UPGRADE FOR HYDRAULIC RETAINER ON STERILIZERS (“UNIBLOC-2” Version)

Gea Procomac would like to take this opportunity of informing that there is a possibility of modifying the seal which isolates the environment of the bottle sterilizer from the outside. The upgrade consists in replacing the retaining seal with a water barrier (hydraulic retainer) which prevents the outflow of peracetic steam from the sterilizer.

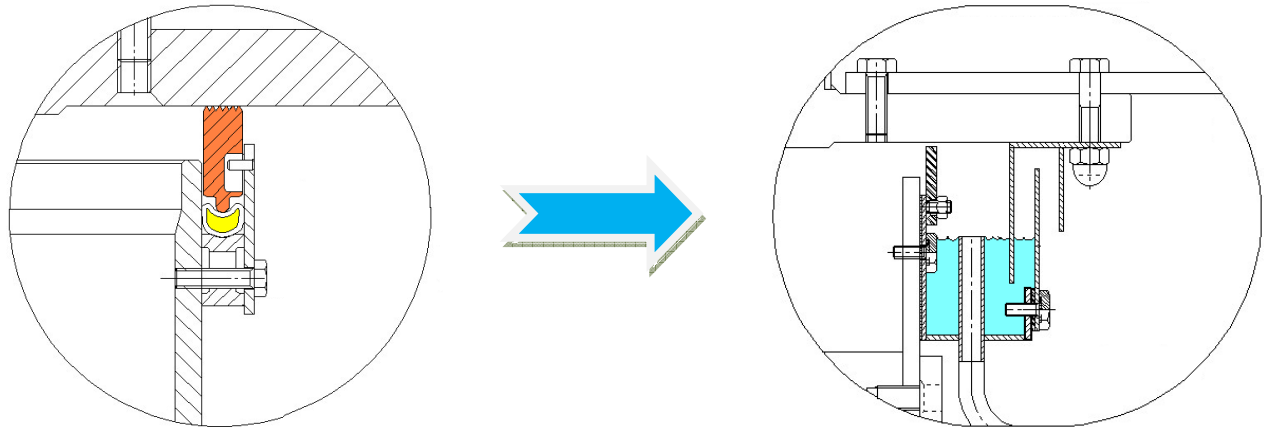
The hydraulic retaining which GEA Procomac installs on the lines of the latest generation, can be applied on the sterilizers in your possession by means of installing an appropriate channel on the machine's carousel (the fixed part) and a carter on the rotating part.

This channel is powered by treated water through a special hydraulic circuit. The automatic handling of the powered circuit assures a constant level in the hydraulic retainer in addition to a constant drain which allows a steady water replacement in the channel (to avoid an excessive residual of peracetic in the water).
